Date: 11 August 2025
Our Reference: J001451
Your Reference: DEV2024/1507

Site Address:	332-334 Water Street and 30A Trinity Street, Fortitude Valley
Property Description:	Lot 1 on RP10553, Lot 11 and Lot 12 on RP10552, Lot 5, Lot 6 and Lot 94 on SP266307, Lot 13 on RP81335, Lot 955 on SP206840 and Easement A on SP143465
Method of Distribution:	Email [peita.mcculloch@edq.qld.gov.au]
Correspondence Subject:	Response to Information Request Pursuant to s.83 (1) of the <i>Economic Development Act 2012</i>

FURTHER ISSUES RESPONSE

Figure 1 – Summary of Proposed Changes

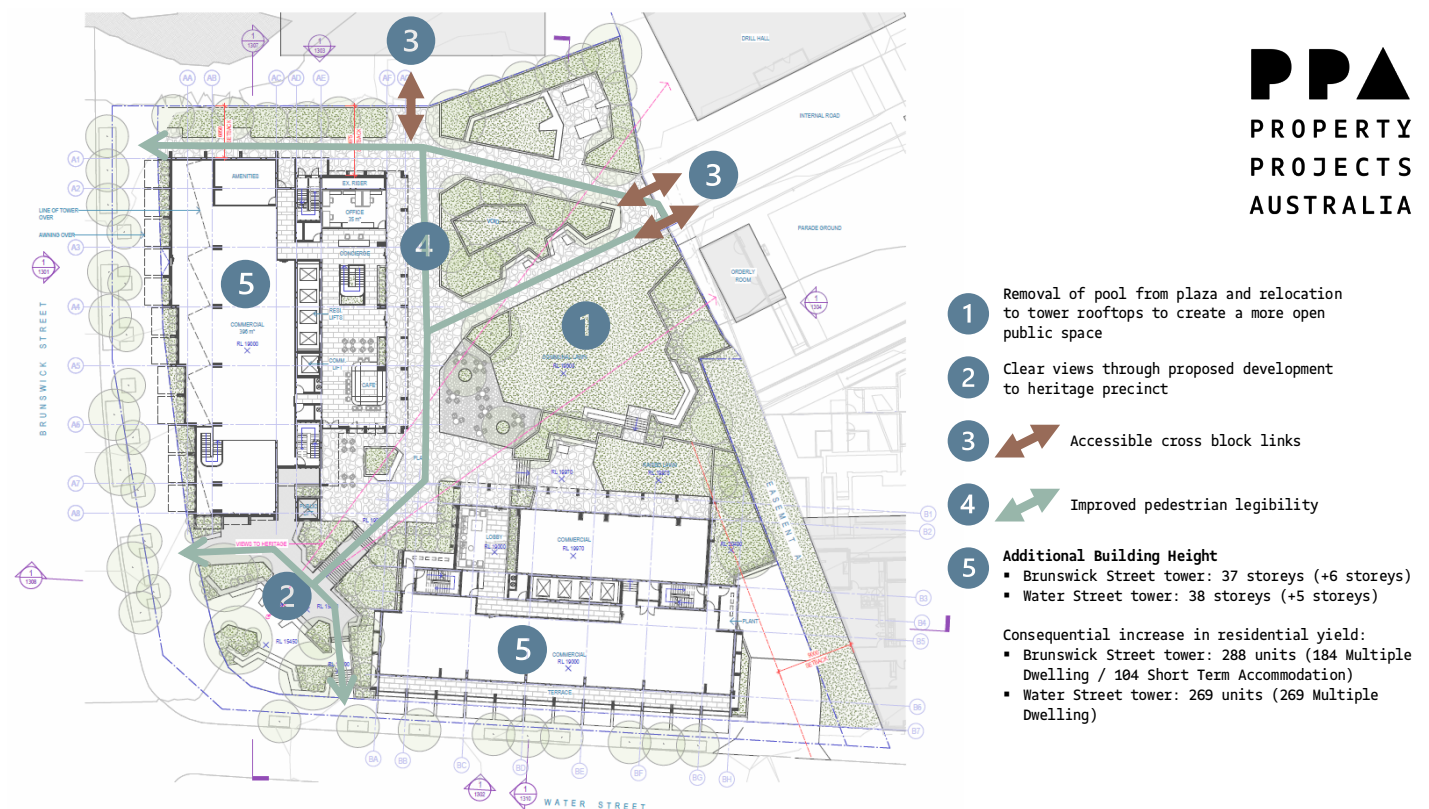
- Relocation of the communal recreation area (including the swimming pool) to the rooftop levels of both towers, removing its dominant presence from the ground plane and enabling the civic plaza to function as a generous and engaging public space.

- Redesign of the civic plaza to deliver a more generous, legible, and publicly accessible urban space that supports social interaction, community activities, and cultural events.

- Incorporation of two (2) publicly accessible cross-block links providing generous, accessible and CPTED-compliant pedestrian connections from both Water Street and Brunswick Street to the civic plaza, improving permeability and public movement through the site.

- Addition of six (6) storeys to the Brunswick Street tower and an addition of five (5) storeys to the Water Street tower, resulting in a revised built form of:
 - Brunswick Street tower: 37 storeys
 - Water Street tower: 38 storeys
- An increase in residential yield, resulting in a total of [80] new apartments across both towers:
 - Brunswick Street tower: 288 units (184 MUD / 104 STA)
 - Water Street tower: 269 units (269 MUD / 0 STA)

Extract 1 - Previously Proposed Plaza Design
Source - Woods Bagot

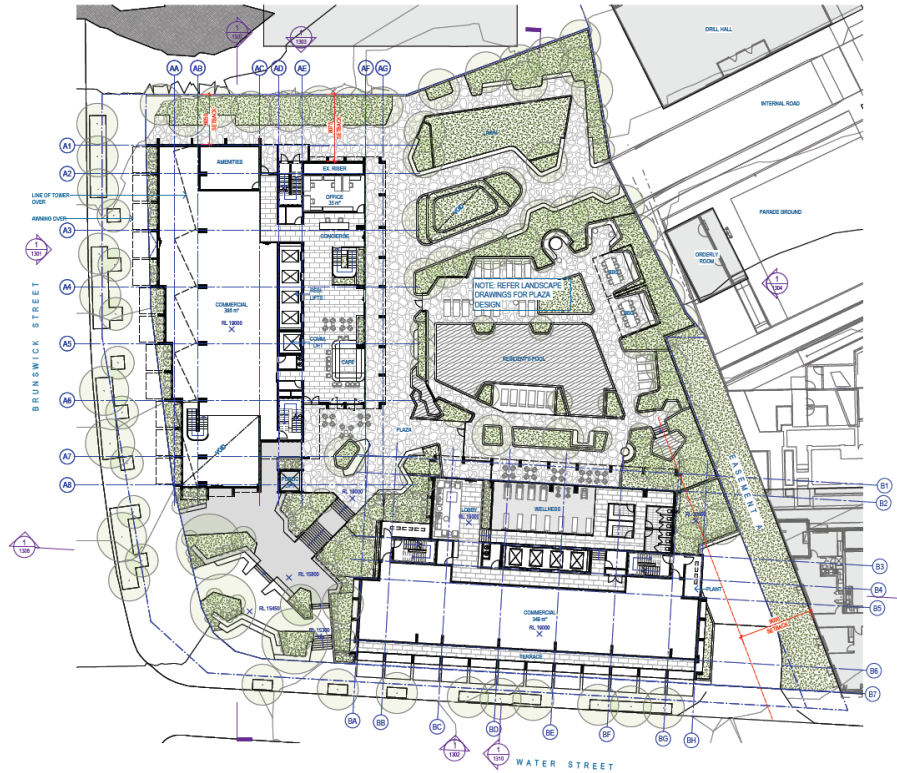
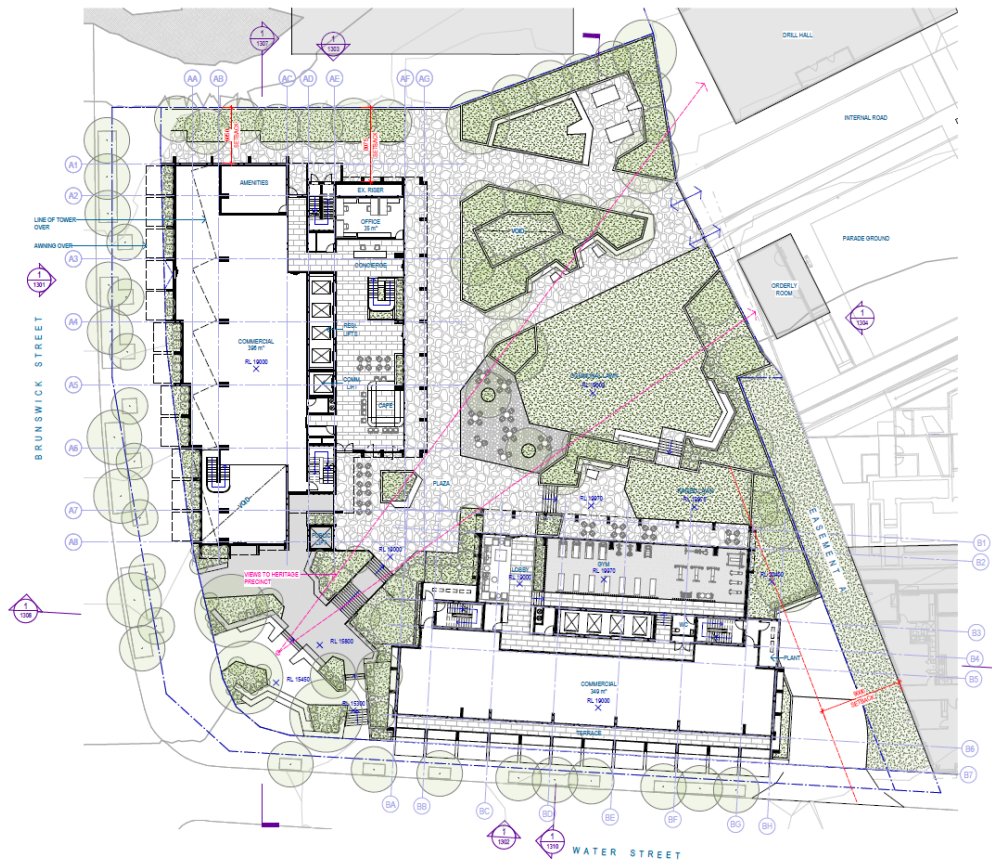
- a. a more generous, publicly accessible and legible civic plaza which encourages social interaction, community and group activities, information, art and cultural activities and events; and
- b. two (2) x publicly accessible cross block links that provide generous, accessible and legible pedestrian connections from the streets to the civic plaza.

The current location of the private communal open space swimming pool significantly impacts the achievement of the public cross block link and civic plaza by dominating the space. It is requested that the redesign remove and/or significantly reduced and relocate the current pool so that it compliments rather than dominates the civic plaza.

- The revised design includes the relocation of the communal swimming pool from the plaza to the rooftops of each residential tower, enhancing the role and function of the civic plaza and the precinct's role as a civic landmark aligning with strategic planning objectives of the PDA Development Scheme promoting accessibility, urban connectivity, and social inclusion.

- The plaza layout has been carefully reworked to improve spatial clarity, function, and comfort. The revised design supports informal social interaction and programmed cultural activity, underpinned by new landscaping, seating opportunities, and material treatments that accommodate diverse passive and active uses.

- Enhanced permeability and movement across the site, two clearly defined public cross-block links are now included:
 - A north-south connection from Brunswick Street along the northern boundary; and

- An east-west connection from the prominent corner through to the civic plaza and Heritage Precinct.

Extract 5 – Typical Floor Plan (Level 6 – 12)

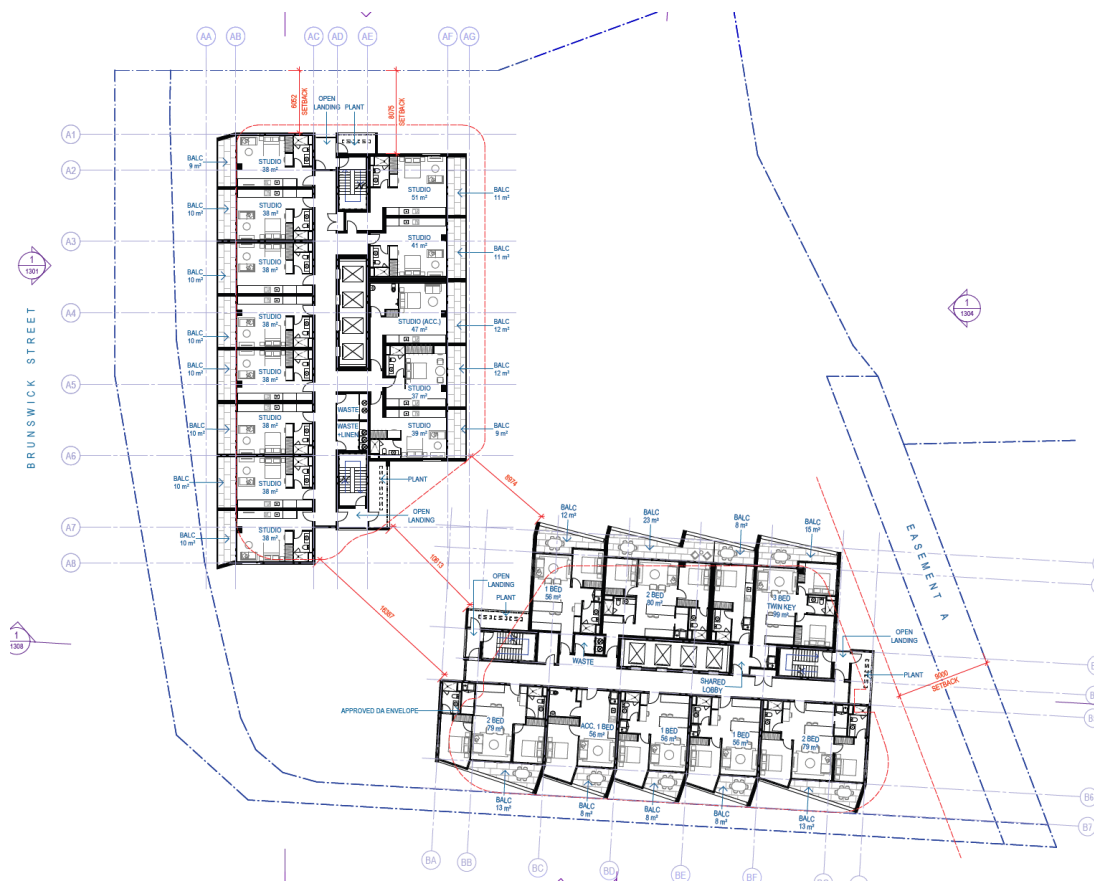
The proposed development does not meet the required street and side setbacks, and the required tower separation distances as per the Scheme. Provide amended plans and/or detailed justification as to how the PDA-wide criteria such as delivering access to light, minimizing over shadowing and maximizing amenity and privacy for both occupants and neighbors is achieved with the proposed reduced building setbacks/separation distances. Prepare and submit wind and solar studies that justify any proposed variation, along with an amenity report where appropriate.

- Substantial tower separation has been incorporated into the design providing 8.9m to 16m of distance between the towers. The orientation and siting of the towers area intentional so as to not compromise the amenity of the occupants / residents in either tower.

- The layout of the floor plans has also been intentionally considered to avoid any direct overlooking into the neighbouring tower, with no direct view or angle into habitable areas. As can be seen below, the habitable rooms and private open space areas have been orientated away from the adjacent tower either overlooking the public plaza or the road network, with no direct overlooking of the adjacent tower.

Extract 12 - Deep Planting Area - Plaza

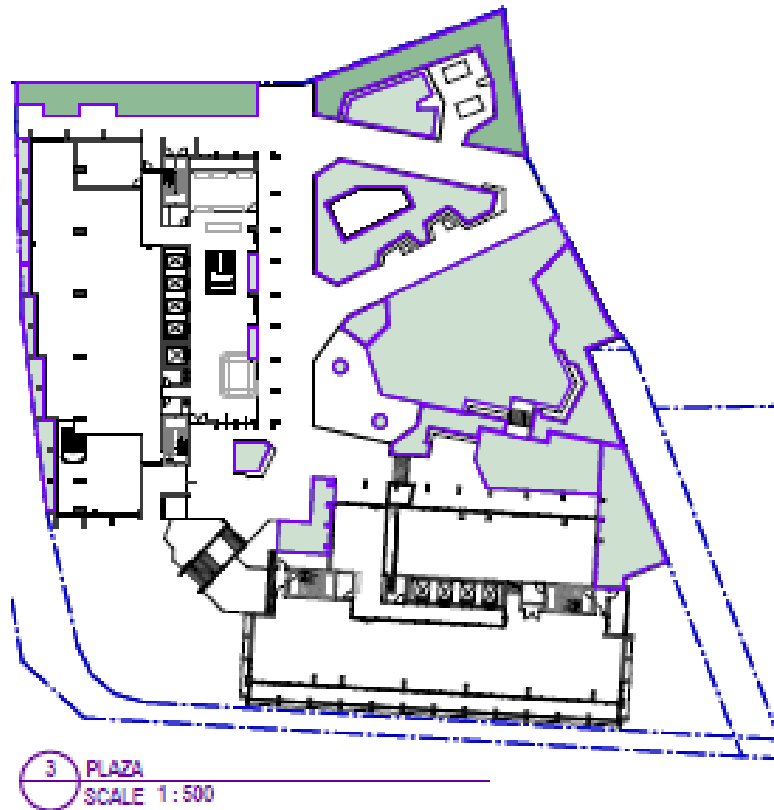
- a. 20 per cent of site area, including 5 per cent of site area as deep planting, within a 5.0 metres minimum dimension; and
- b. along a minimum length of 50% of street frontages. Provide detailed plans that clearly identify the amount of landscaping and deep planting proposed.

Provide detailed plans that clearly identify the amount of landscaping and deep planting proposed.

The proposed Plaza will have substantial landscaped area, including an area of 197m² for deep planting (with an additional 224m² at lower ground), large canopy trees and dense layered planting, that sits at the centre of the development to benefit all future residents and users. The proposal comfortably complies with the minimum deep planting area of 5% with 421m² or 8% of the site area as deep planting provided (based on the pre-land dedication site area). Further to this, the proposed development provides a total planted area of 1,970m², which again comfortably achieves the prescribed minimum of 20% at 27.3%.

It is not possible to provide a minimum length of 50% landscaping along the street frontages as deep planting cannot be achieved due to the levels of the site, however, this has been balanced through the provision of substantial containerised planting to enable a green edge along the street frontages. Through streetscape upgrades, the streetscape of Water Street and Brunswick Street will be enhanced to provide planted areas and street trees that will contribute to the overall greening of the street frontages.

Extract 15 – Pedestrian Circulation and Access Strategy

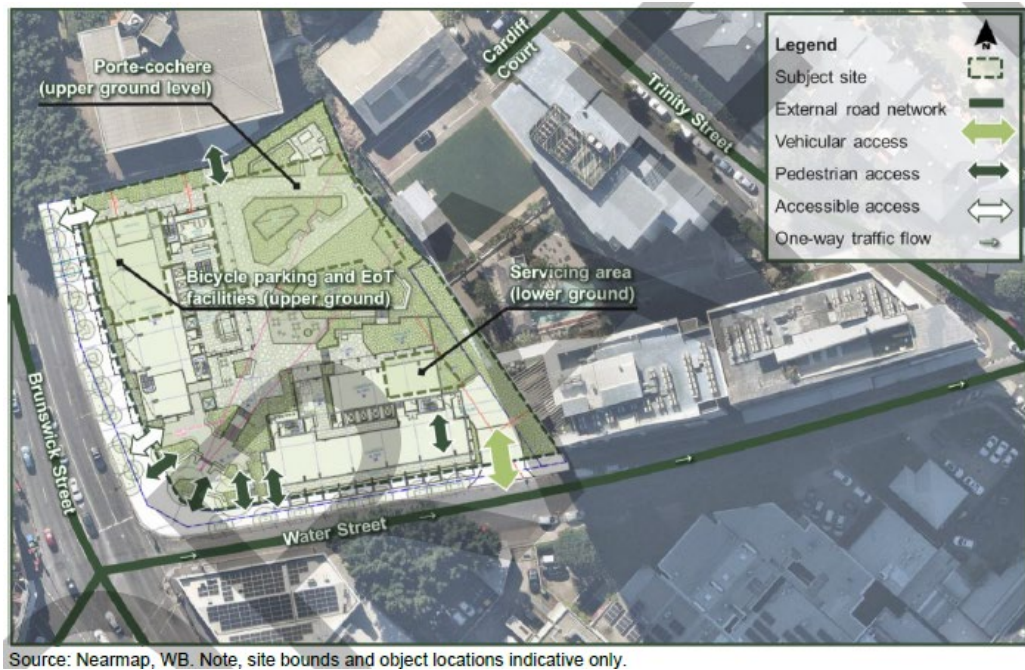
- b. Identify a pedestrian movement strategy/plan into and within the development site and demonstrate that the operation and configuration of the layout is adequate with regard safety of pedestrians.

- b. The pedestrian circulation and access strategy is included at page 14 of the Revised Landscape Report at **Attachment 4** as extracted below.
